Project	IEEE 802.16 Broadband Wireless Access Working Group < <a href="http://ieee802.org/16">http://ieee802.org/16</a> >	
Title	Problems with DBPC Messages and a Solution	
Date Submitted	2005-01-26	
Source(s)	<p>David A Castelow, Gavin Meakes, Eyal Verbin Airspan Communications, Cambridge House, Oxford Road, Uxbridge, UK</p> <p>Rainer Ullmann, Donald Stevenson Wavesat Inc 1375 Trans-Canada Highway Suit 300 Dorval, Quebec H9P 2W8 Canada</p> <p>Chi-Chen Lee, Tzu-Ming Lin, Yu-Ren Yang, Chia-Feng Kang, Computer &amp; Communications Research Laboratories, Industrial Technology Research Institute, Chutung, Hsinchu, Taiwan 310, R.O.C.</p>	<p>Voice: +44 1895 467281 Fax: +44 1895 467202 <a href="mailto:dcastelow@airspan.com">mailto:dcastelow@airspan.com</a></p> <p><a href="mailto:rullmann@wavesat.com">mailto:rullmann@wavesat.com</a></p> <p><a href="mailto:jjlee@itri.org.tw">mailto:jjlee@itri.org.tw</a></p>

Re:	Supporting document for Comment 612 and Reply to Comment 084 (802.16-04/04r9)	
Abstract	Changes required in order to enable good operation of 802.16 systems.	
Purpose	The document is intended for consideration within the comments resolution process.	
Notice	This document has been pr

**Figure 79—Transition to a more robust burst profile**

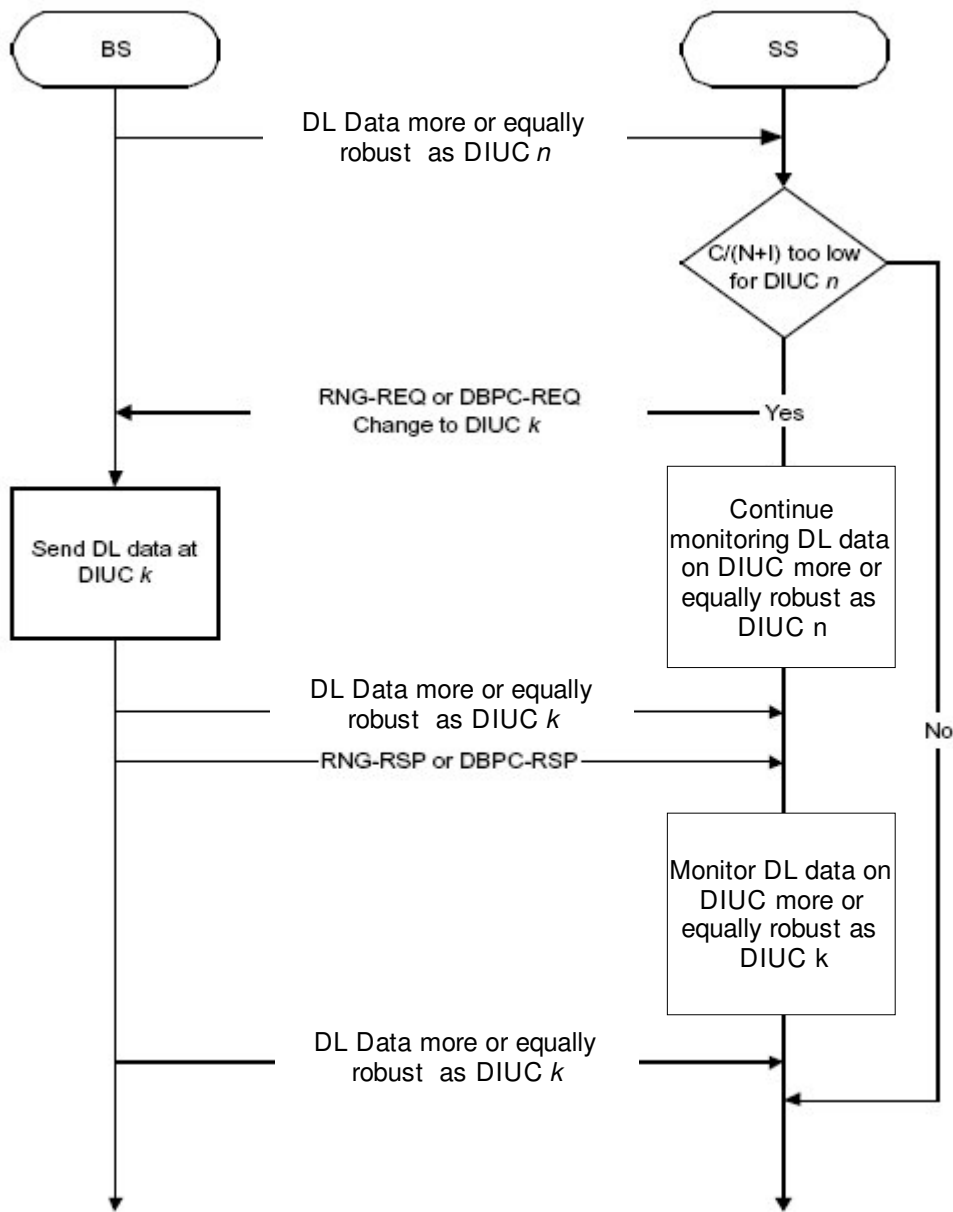
Page 203: Figure 79 needs to indicate action of SS in event of non-detection of DBPC-RSP.

Also DL data may be on DIUC up to m, not at m. This requires a change to Figure 79 also.

Change Figure 79 as indicated:

**Figure 80—Transition to a less robust burst profile**

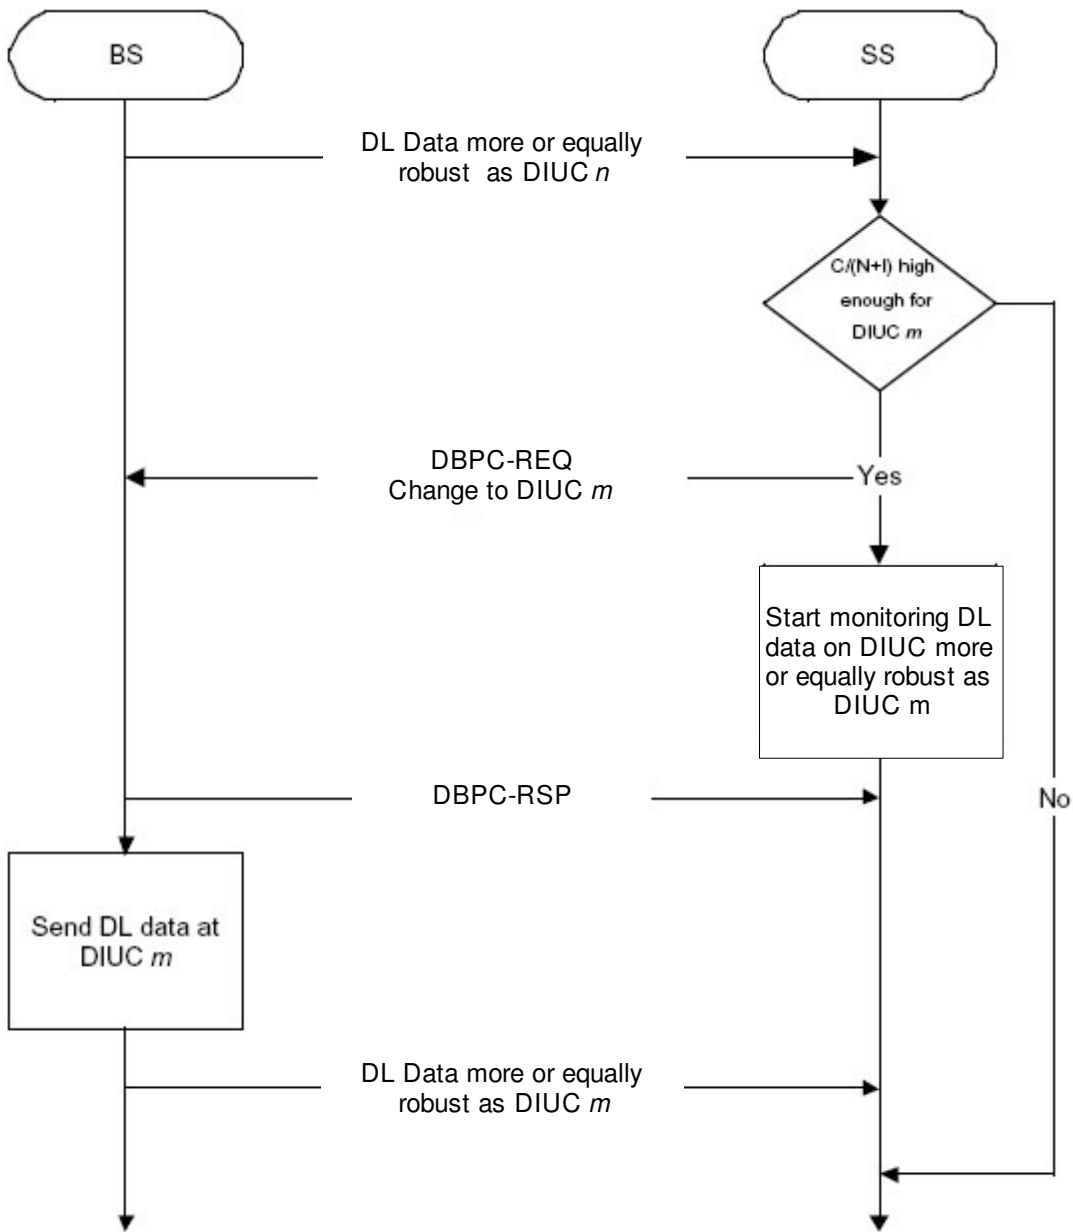
Page 204: Figure 80 needs to indicate action of SS in the event of the BS refusing the DBPC-REQ to move to a less robust modulation.

Change Figure 80 as indicated, as RNG-REQ only to be used for transition to more robust cases when no grant is available (see 6.3.10.1).

Figure 80a – State transition diagram for downlink burst profile management – SS

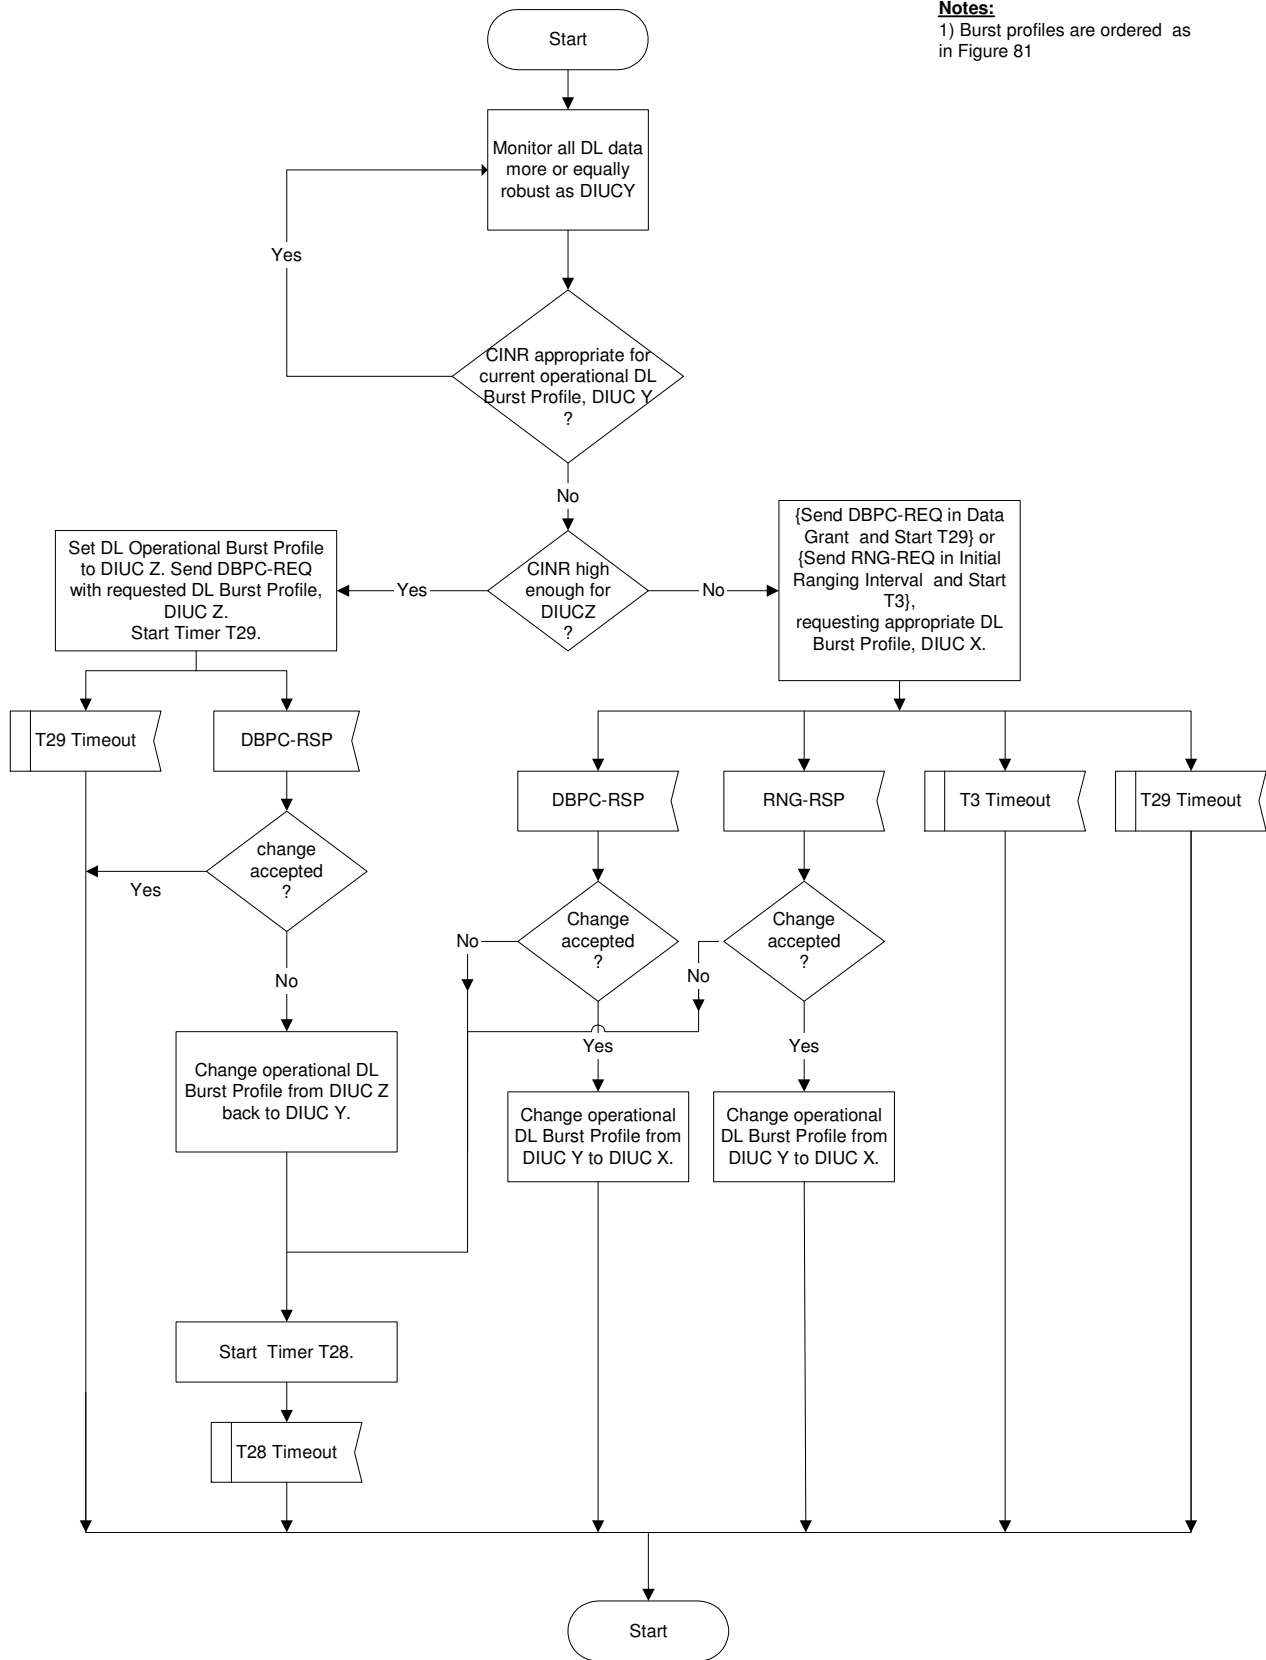
State transition diagrams are needed here, so rather than complicate these diagrams, we introduce a separate figure. This diagram requires timers, so that the BS is not flooded with requests. The diagram (Figure 80a) indicates the actions for the SS, and includes a new timer (T28).

Insert new Figure 80a (see end of contribution).

System	Name	Time reference	Minimum value	Default value	Maximum value
SS	T28	Minimum Time between transmission of downlink burst profile control messages (RNG-REQ/DBPC-REQ).	200 ms	1 s	1 min
SS	T29	DBPC-RSP reception timeout following the transmission of a DBPC-REQ.	200 ms	200 ms	200 ms
